Scoping and Environmental Impact
Assessment for the Proposed
Construction and Operation of the
up to 240 MWac Ingwe Wind Energy
Facility 2 and associated
infrastructure, near Molteno
in the Eastern Cape

**FINAL ENVIRONMENTAL
IMPACT ASSESSMENT REPORT**

COMMENTS *and*
RESPONSES
REPORT

July 2023

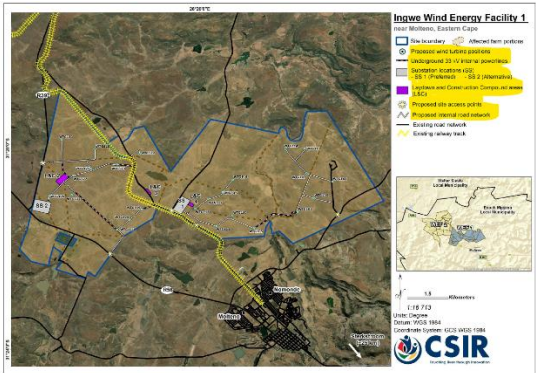
21.	<p>19/07/2023 Letter (received via email on 19/07/2023), Rainmaker Energy Projects (Pty) Ltd (XXXX)</p>	<p>Be that as it may, Rainmaker Energy would like to to be registered as an I&AP and would recommend that the DFFE request that a Wake Agreements in respect of Rainmaker Energy's aforementioned wind projects (or at the very least a Memorandum of Understanding committing to the establishment of a Wake Agreement) be established by the Applicant prior to EA approval, to circumvent any potential negative impacts.</p>	<p>APPLICANT:</p> <p>Rainmaker is already registered, as shown in Appendix C of the EIA Report and demonstrated through initiation of engagement as mentioned above.</p> <p>The Applicant is happy to commit to the establishment of a wake agreement between the parties. The wake agreement itself is, however, a commercial aspect not linked to environmental factors and the Applicant is of the view that it should not be linked to Environmental Authorisation (if granted). Detail design and final turbine selection would follow EA; therefore, conclusion of a Wake Agreement prior to EA is premature and would be based on a level of</p>
